7280 N. Nevada Lane

Drainage letter

ALL TERRAIN ENGINEERING PROJECT NO: 24020

EL PASO COUNTY PROJECT # - PPR-2411

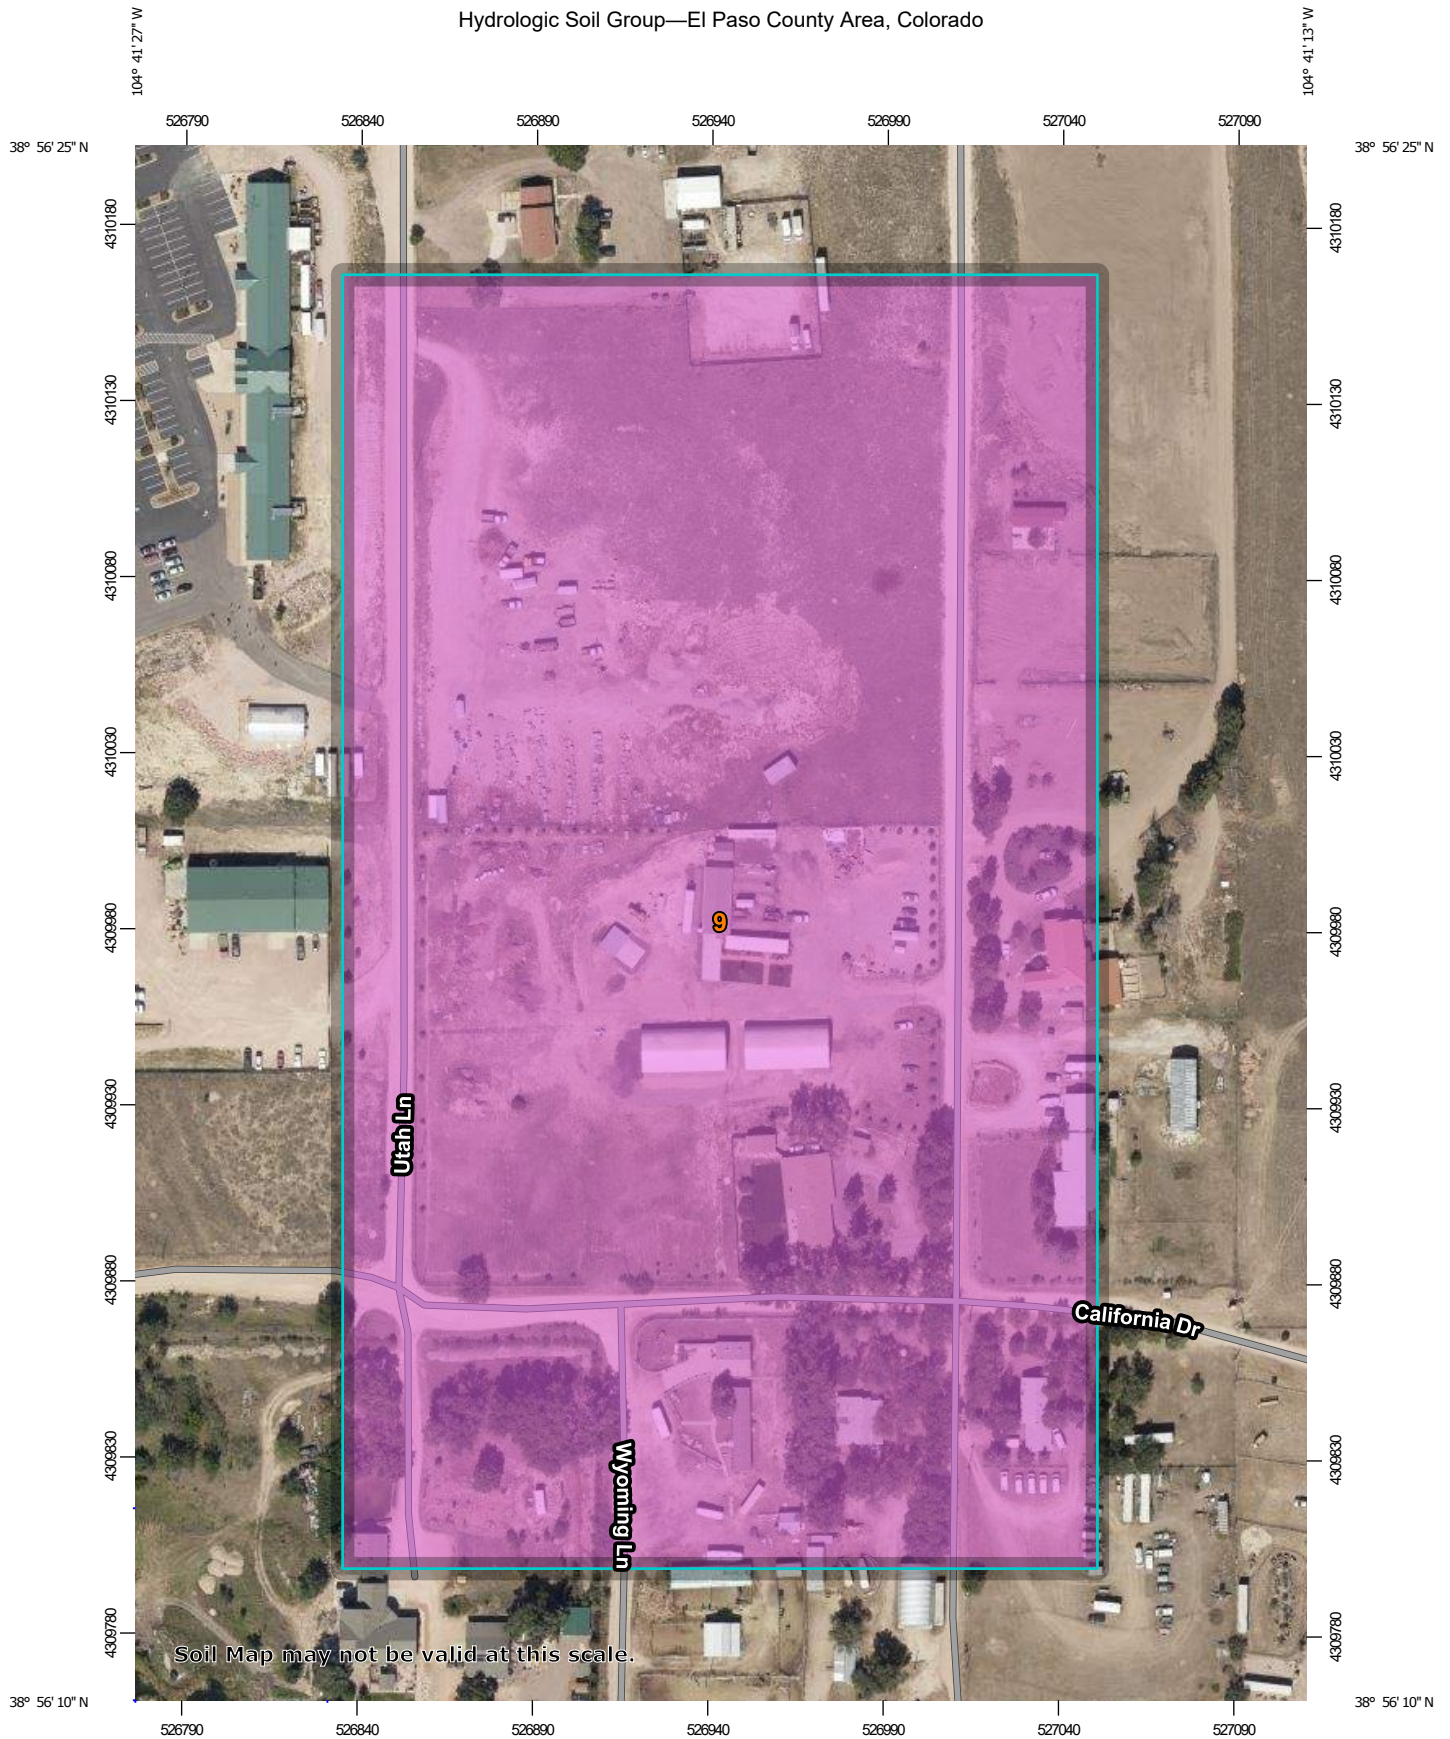
Please delineate the subject project on the Vicinity map.

PROPOSED DRAINAGE MAP

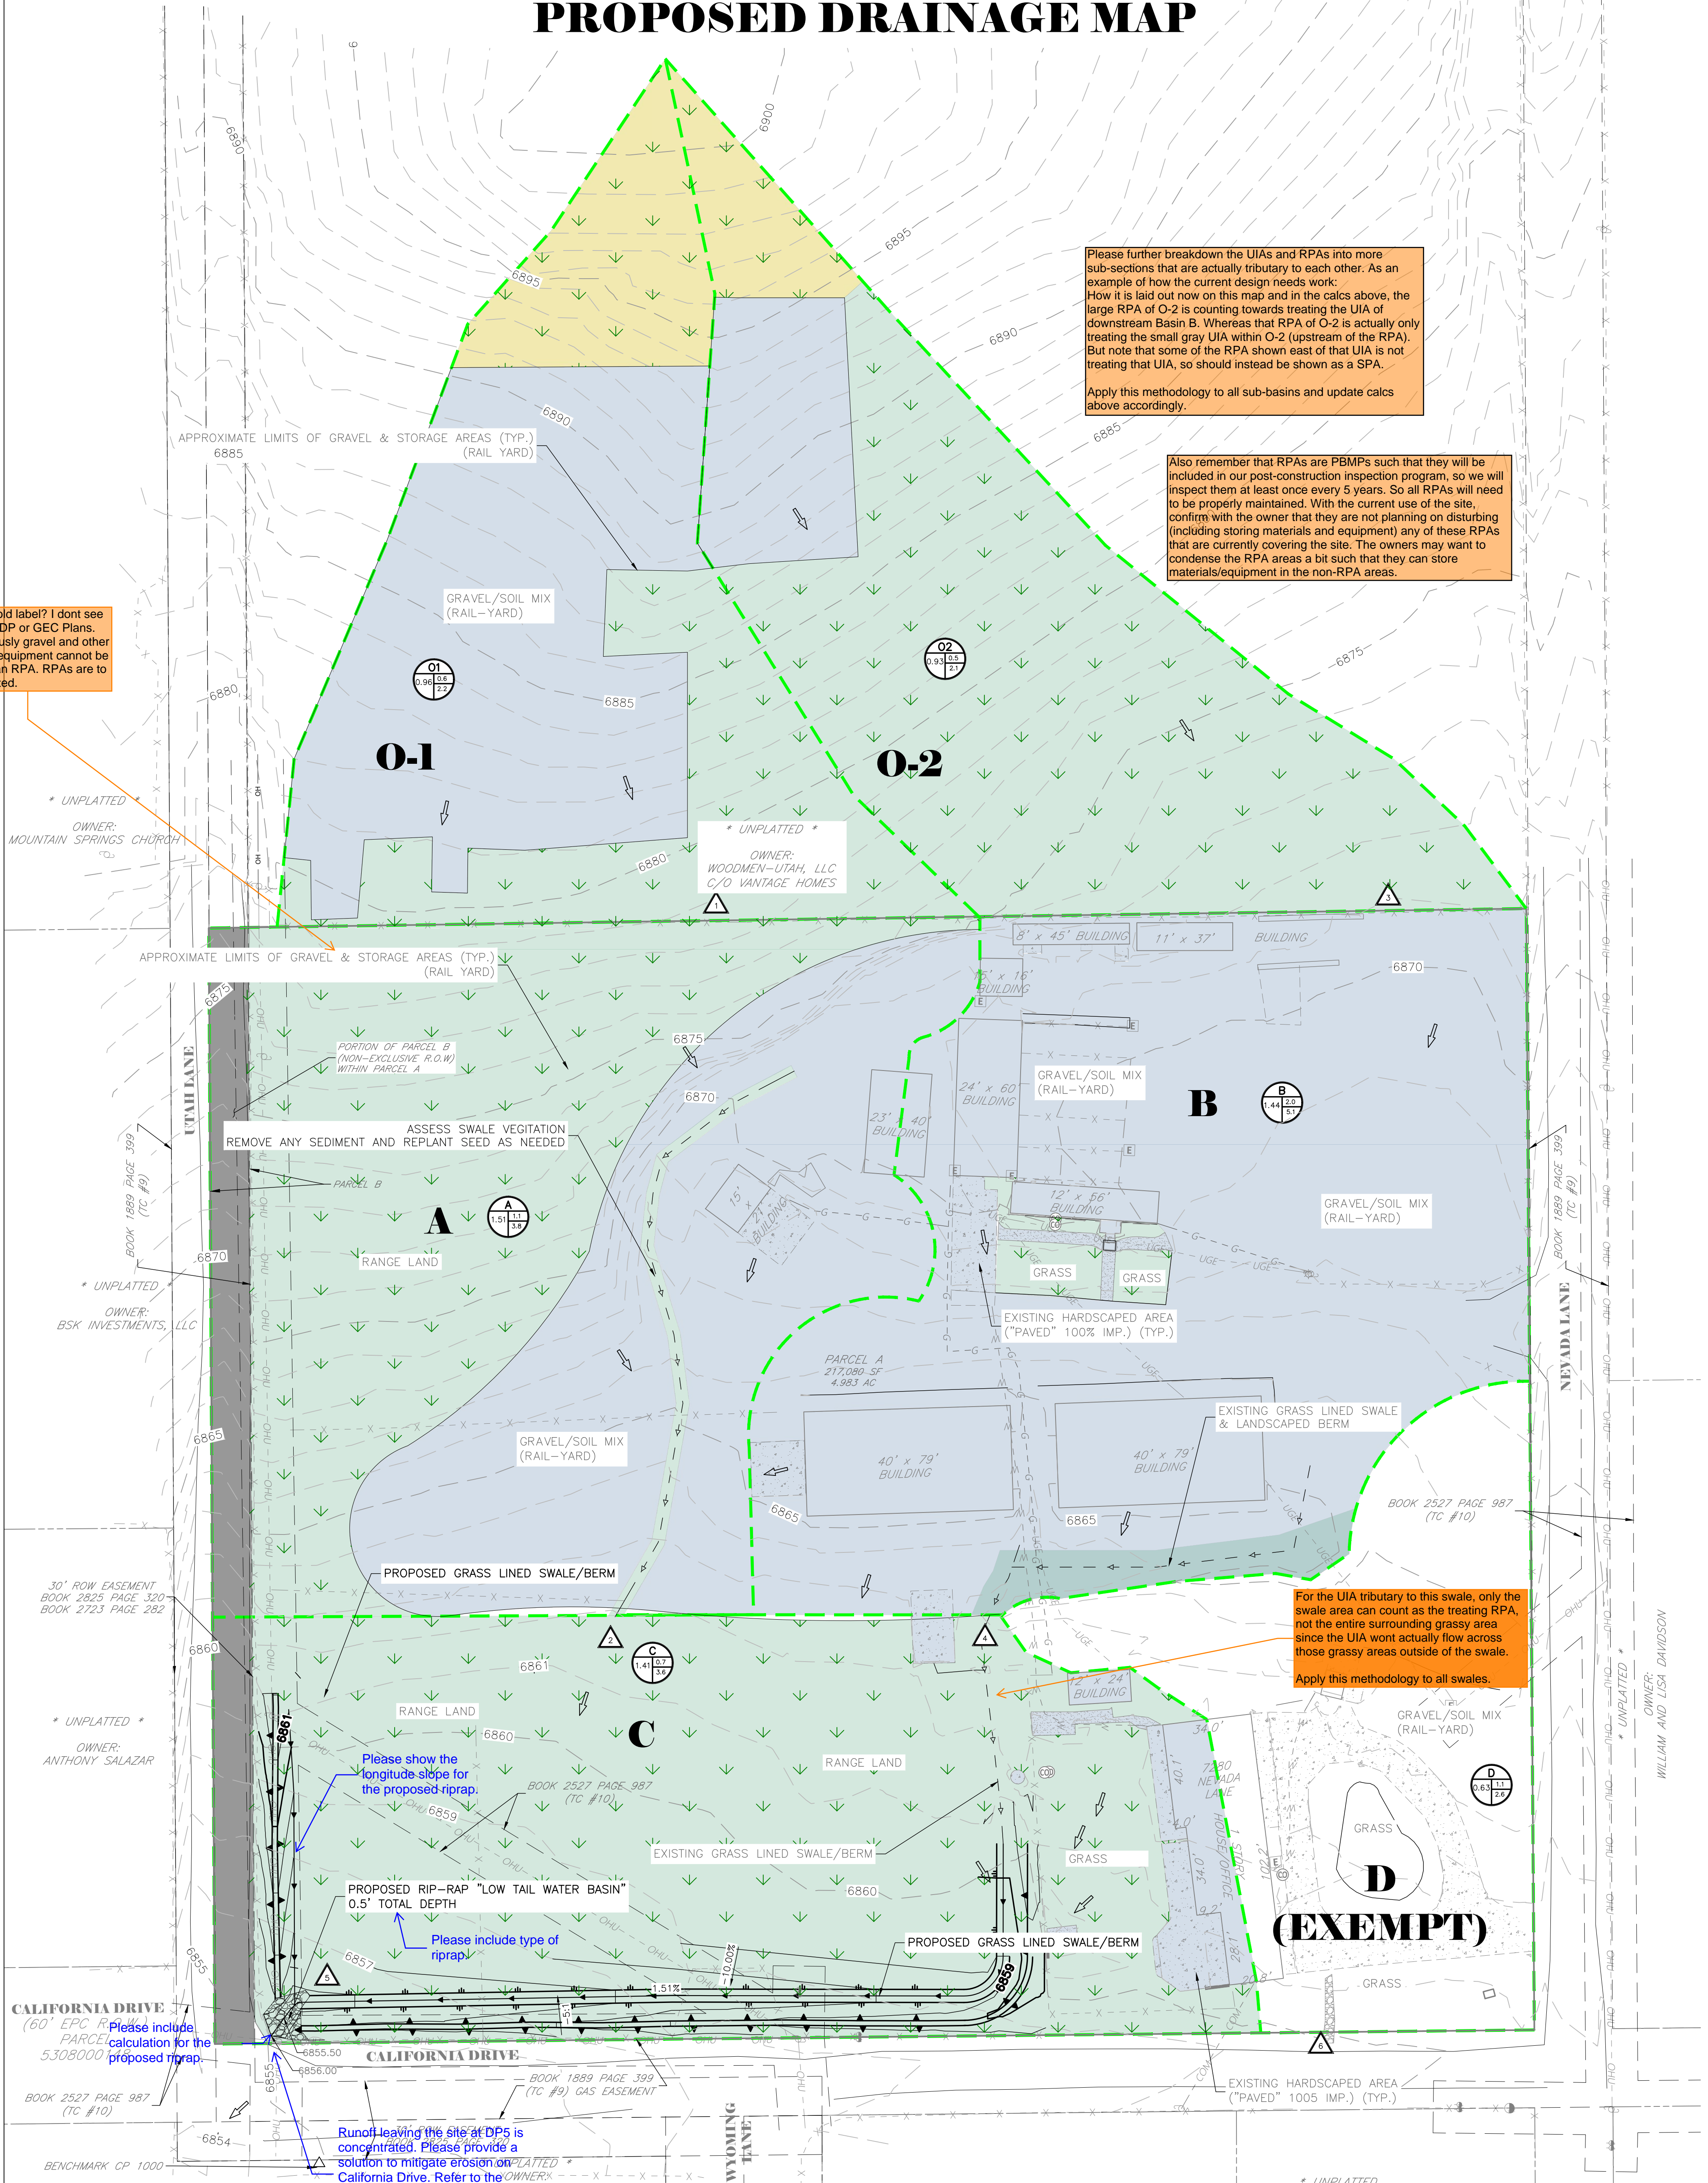
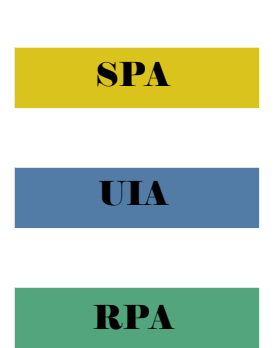
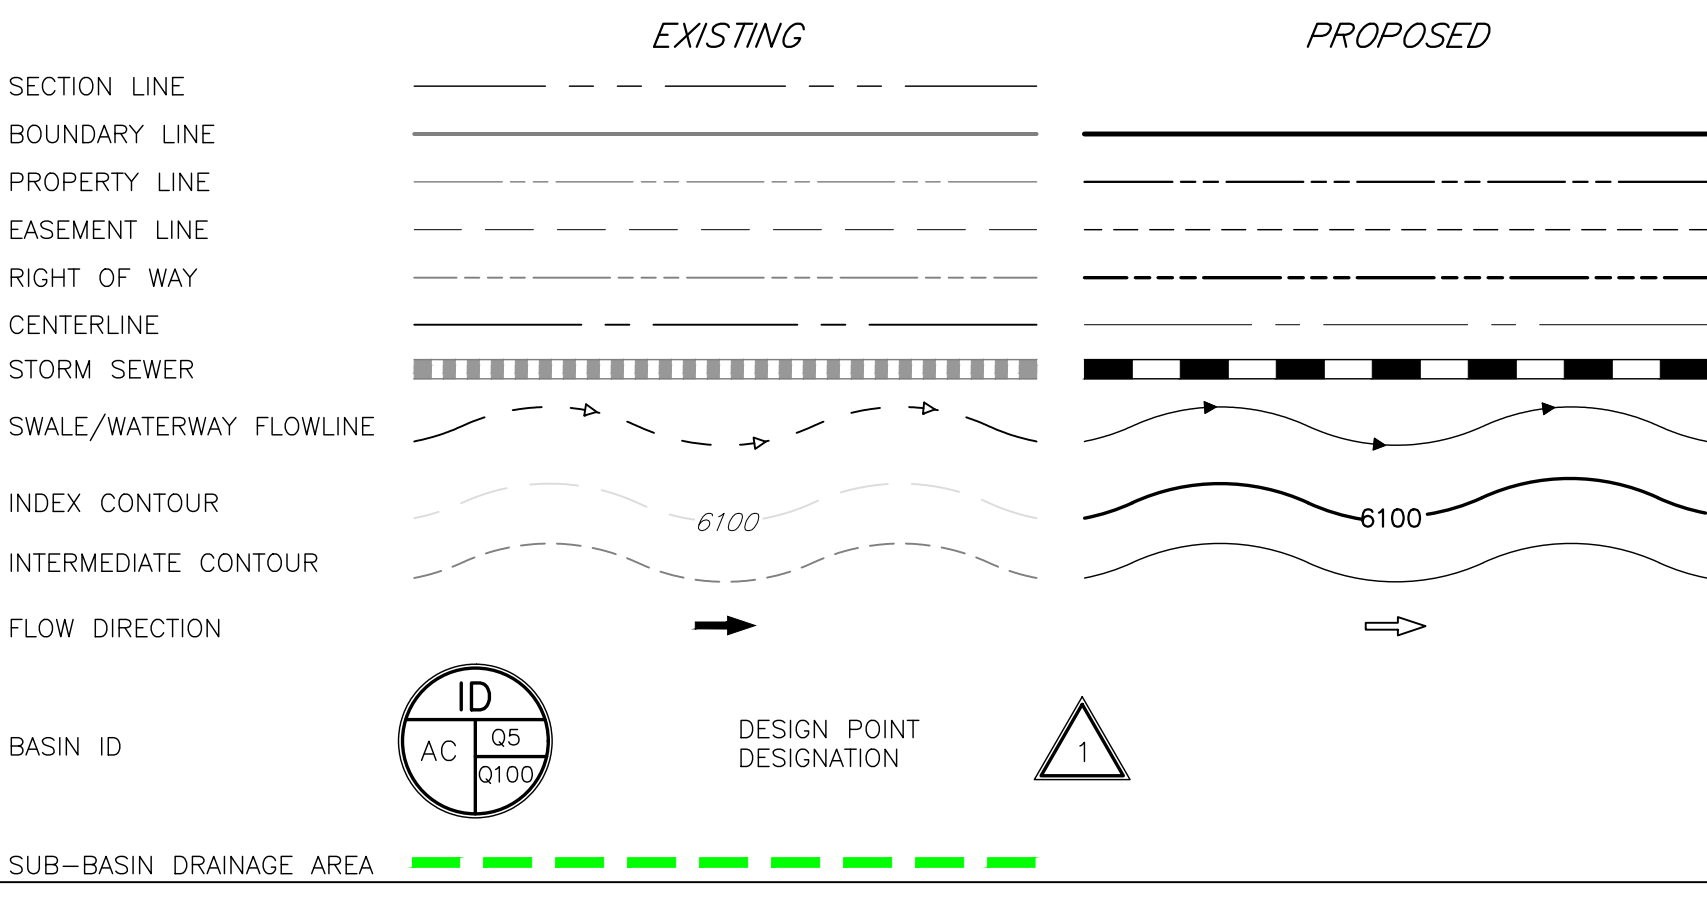
Missing the existing drainage map.

Is this an old label? I dont see it on the SDP or GEC Plans. And obviously gravel and other materials/equipment cannot be stored in an RPA. RPAs are to be vegetated.

Please further breakdown the UIAs and RPAs into more sub-sections that are actually tributary to each other. As an example of how the current design needs work: How it is laid out now on this map and in the calcs above, the large RPA of O-2 is counting towards treating the UIA of downstream Basin B. Whereas that RPA of O-2 is actually only treating the small gray UIA within O-2 (upstream of the RPA). But note that some of the RPA shown east of that UIA is not treating that UIA, so should instead be shown as a SPA.

Apply this methodology to all sub-basins and update calcs above accordingly.

Also remember that RPAs are PBMPs such that they will be included in our post-construction inspection program, so we will inspect them at least once every 5 years. So all RPAs will need to be properly maintained. With the current use of the site, confirm with the owner that they are not planning on disturbing (including storing materials and equipment) any of these RPAs that are currently covering the site. The owners may want to condense the RPA areas a bit such that they can store materials/equipment in the non-RPA areas.

For the UIA tributary to this swale, only the swale area can count as the treating RPA, not the entire surrounding grassy area since the UIA wont actually flow across those grassy areas outside of the swale.

Apply this methodology to all swales.

Please show the longitude slope for the proposed riprap.

Please include type of riprap.

Runoff leaving the site at DPs is concentrated. Please provide a solution to mitigate erosion on California Drive. Refer to the comments in Review 02 for additional details.
